# Review of Engineered Barrier System (EBS) topics in Posiva's construction license application for a spent fuel repository at Olkiluoto, Finland

Michael Apted (ed.)  
INTERA Inc., Austin, Texas

*APTED Michael [INTERA Inc] (ed.). Review of Engineered Barrier System (EBS) topics in Posiva's construction license application for a spent fuel repository at Olkiluoto, Finland. STUK-TR 18. Helsinki 2015. 34 pp.*

**Figure 2.** Figure 2.3 from Posiva 2012-12, showing Posiva’s outline of its pillars of safety, including “slow release from the spent fuel matrix”

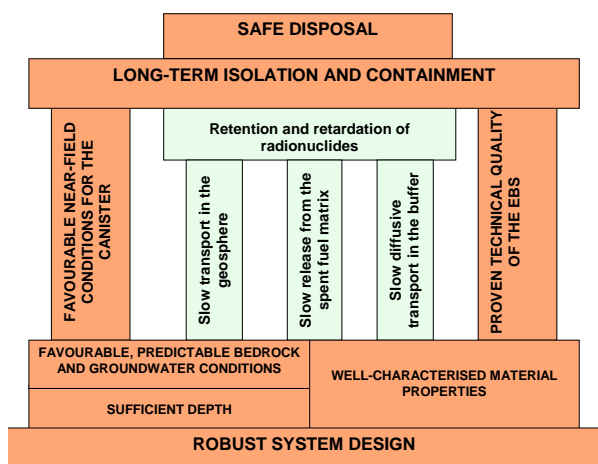
Furthermore, sensitivity analyses by Posiva show that a basic property of spent fuel, the measured low dissolution rate of UO<sub>2</sub> matrix, provides one of the most significant contributions to safety in the KBS-3 system (Posiva 2012-12). This is consistent with other internationally developed safety cases for disposal of spent nuclear fuel where the long-term, slow dissolution rate is considered a key part of the basis for geological disposal (e.g., SKB, 2006). "Slow release from the spent fuel matrix"

has long been recognized by Posiva as one of its key pillars of safety [Figure 2].

The dissolution rate of  $\text{UO}_2$  is a basic, measurable property of a component that always will be present in any direct disposal system (unlike, for example, the assumed properties of a hypothetical undetected ‘pinhole’ in the weld of a copper canister). It may be merely a matter of semantics, but neither Posiva nor STUK should lose sight of the importance of processes and barriers that may have no assigned Safety Functions, but nonetheless are highly significant contributors to post-closure safety.

**Figure 3.** Figure 8-6a from Posiva 2012-12, showing relative lack of impact on peak radionuclides release rate for a variety of alternative far-field assumptions and models.

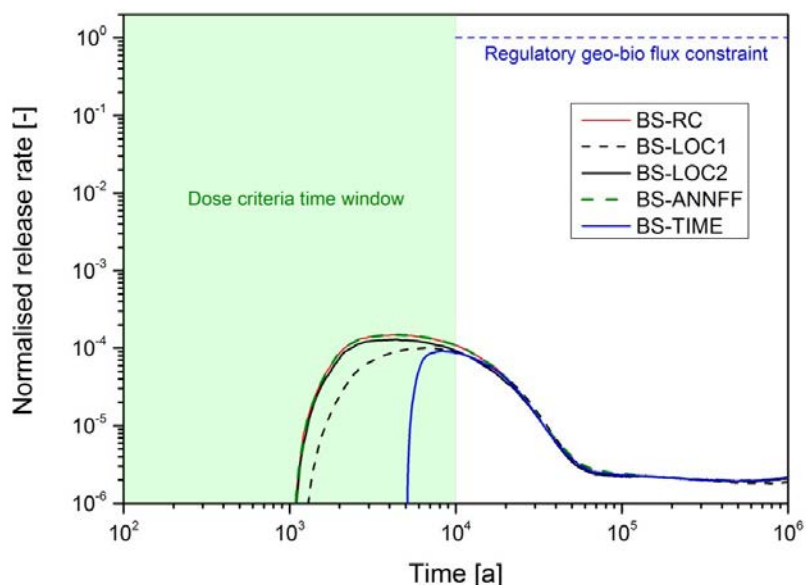
The limited sensitivity analyses around variant scenarios to the Reference Case, as illustrated by Figure 8-6a in Posiva 2012-12 (Figure 3), show relatively low (negligible) safety-significance of certain alternative assumptions and safety functions of the far-field host rock and hydrogeology; clearly it is the performance of the EBS that dominates the safety of the KBS-3 system.

**Figure 5.** Figure 8-17 from Posiva 2012-12, showing the relative safety ranking of various barriers and properties affecting peak Cs-135 release rate.

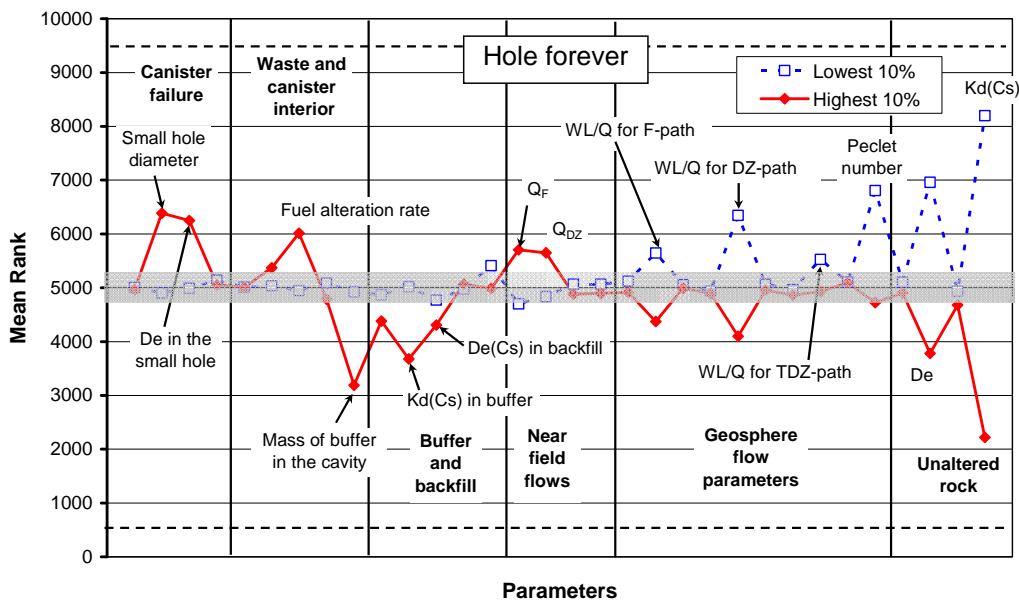
The robustness in Posiva’s CLA post-closure safety assessment, however, is difficult to judge since Posiva presents somewhat circular reasoning for its design basis case. For example, Posiva 2012-12 (page 52) states:

In essence this says the obvious that if everything works and evolves as expected, then performance assessment shows that the repository system will safely isolate the spent fuel.
